SUBJECT: NuScale Power, LLC Response to NRC Request for Additional Information No. 232 (eRAI No. 9113) on the NuScale Design Certification Application

REFERENCE: U.S. Nuclear Regulatory Commission, "Request for Additional Information No. 232 (eRAI No. 9113)," dated September 21, 2017

Response to Request for Additional Information Docket No. 52-048

eRAI No.: 9113

Figure 1: Reducer Tee and postulated cracks

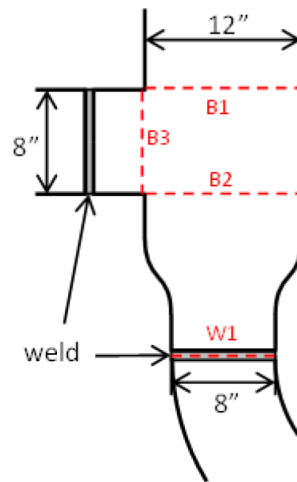
Provide information if the LBB analyses were conducted with postulated crack locations at the following locations, (i) the perpendicular connection between NPS 8" and NPS 12" pipes (Refer to Figures 3.6.2 and 3.6.3 pipe segments 'a' and 'd' respectively shown below) and (ii) the girth welds of the reducer from NPS 12" to NPS 8" elbow shown below (Refer to Figures 3.6.2/3.6.3 segment 'd' and elbow 'f' respectively)

At the perpendicular connection between NPS 8 and NPS 12 pipes, cracks were postulated at locations B1, B2, and B3 as shown in Figure 1 below. At the weld between the reducer and elbow, a crack was postulated at location W1. Cracks at B1 and B2 were included in FSAR Section 3.6.3.2.1 "NPS 12, SCH 120 straight and curved pipe base metal." The crack at B3 was included in "NPS 8, SCH 120 straight and curved pipe base metal." The crack at W1 was included in "NPS 8, SCH 120 pipe-to-pipe weld." Figure 2 through Figure 4 show the resultant Smooth Bounding Analysis Curves (SBAC) and calculated normal and maximum stresses at these locations. Because the stress points are below the SBAC, these locations meet the LBB criteria.

Figure 1: SBACs comparison using various path deviation parameters

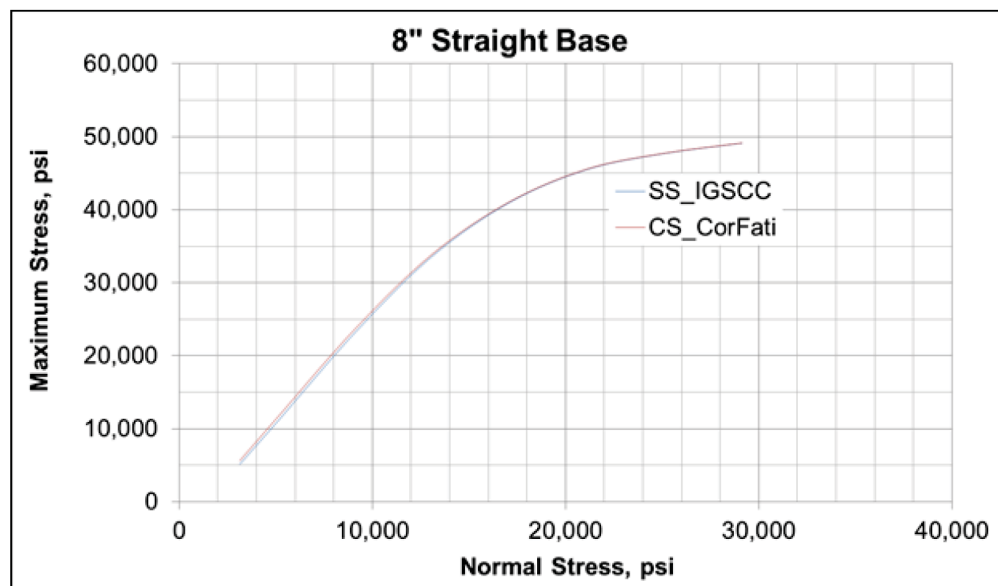
In FSAR Section 3.6.3.2.5, values for some of the listed crack morphology parameters (i.e., roughness, number of turns, flow path/thickness ratio) are for air fatigue cracks and others are for Intergranular Stress Corrosion Cracking (IGSCC) flaws. However, NUREG/CR-6004 also identifies other degradation mechanisms (e.g., corrosion or thermal fatigue) that could result in different crack morphology parameters.

Provide a description and justification for the crack morphology used.

For the parameters K_G and K_{G+L} in Table 1, although the main steam and feedwater piping is not susceptible to SCC (see FSAR Section 3.6.3.1.2), the values used are from stainless steel in IGSCC crack mechanism, because there is no path deviation data for the mechanism of fatigue in air. Using the values from the IGSCC condition is more conservative than using the values from fatigue in air.

As confirmation, a test LBB analysis was performed using the values from NUREG/CR-6004 Table 3.8, for corrosion fatigue in carbon steel. The results were compared in Figure 1, which shows that the SBAC is not sensitive to the path deviation parameter. Using these values from IGSCC in stainless steel gives a more conservative SBAC than using the values from corrosion fatigue in carbon steel. Therefore, it is conservative to use the values in FSAR Section 3.6.3.2.5 in NuScale's LBB analysis.

Figure 1: Bending moment versus leak rate

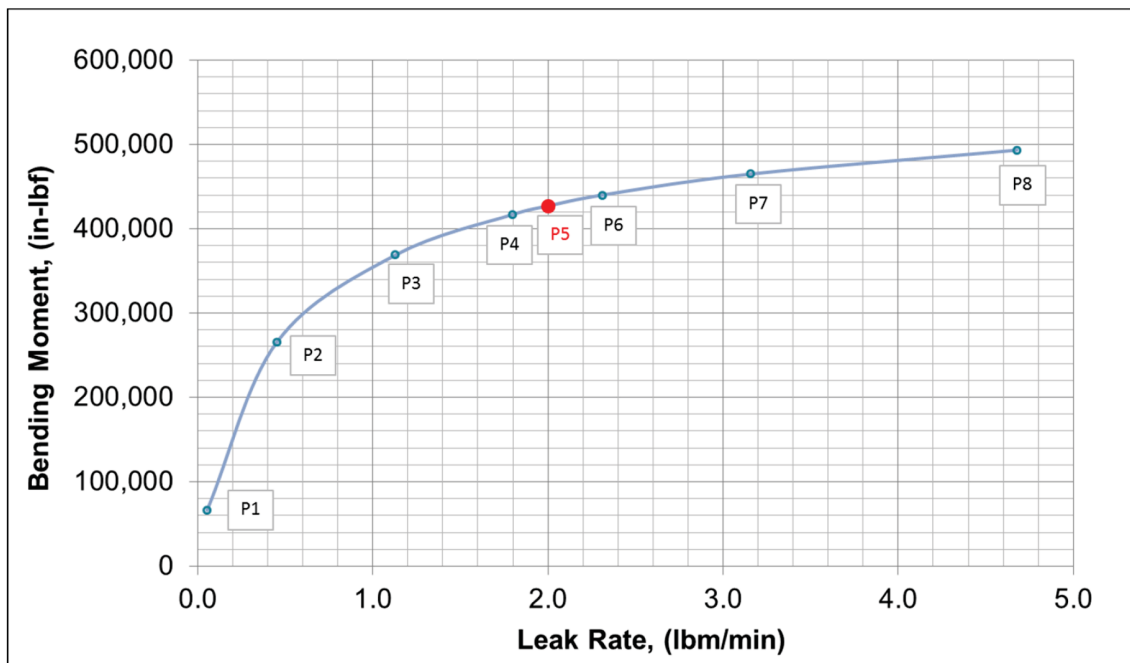
The leak-rate methodology is described in FSAR Section 3.6.3.3.3. No moment versus leak-rate curves are provided in any of the LBB analysis cases. These curves are an intermediate step in the LBB analyses procedure and are needed to verify the margin of safety associated with the Smooth Bounding Analysis Curve (SBAC) approach described in FSAR Section 3.6.3.3.5.

Provide the moment versus leak-rate curves for the LBB cases.

FSAR Table 3.6-3a lists the main steam piping stress points calculated using the approaches described in FSAR Section 3.6.3.3.5. This table was established by fixing leak rate at 0.2 lbm/min (or 2.0 lbm/min after the margin of 10 is applied) in the third step of Section 3.6.3.3.5.

To show the moment versus leak-rate curve, the fourth stress point from the column “NPS 8 base metal” (normal stress: 13,136 psi; maximum stress: 33,733 psi) is taken as an example in the following analysis. At this stress point, the calculated crack length is $\{\{ \}^{2(a),(c)}\}$.

A fracture mechanics and leak rate analysis was performed for a crack length of $\{\{ \}^{2(a),(c)}\}$. By assigning various normal stresses, the corresponding bending moments (described in FSAR Section 3.6.3.3.5 Step 6) and leak rates are calculated as listed in Table 1 below. The resultant bending moments versus leak rates are illustrated in Figure 1. In these data points, the calculated leak rates increase with the assigned normal stresses. At data point P5, the calculated leak rate reaches 2.0 lbm/min, corresponding to the safety margin of 10 for the 0.2 lbm/min leak detection capability. Therefore, the normal stress from point P5 (13,136 psi) is determined as the normal stress being used in the fourth stress point mentioned in the paragraph above.

Figure 1: Crack geometry considered for elbows

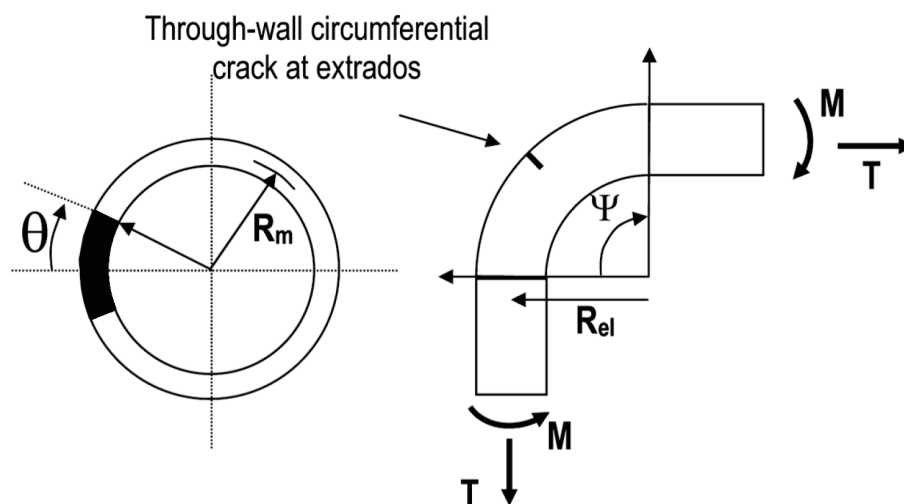
FSAR Section 3.6.3.4.1.6 discusses the load limit analysis for the NPS 8 elbow base metal, however, it does not specify the type and location of crack being analyzed which is critical for an elbow as opposed to a straight pipe. Please clarify if this is a circumferential crack by the girth weld of the elbow, or centered on the extrados, or is it an axial crack on the flank of the elbow.

The crack analyzed for the NPS 8 elbow is the through-wall circumferential crack at extrados, as shown in Figure 1 below.
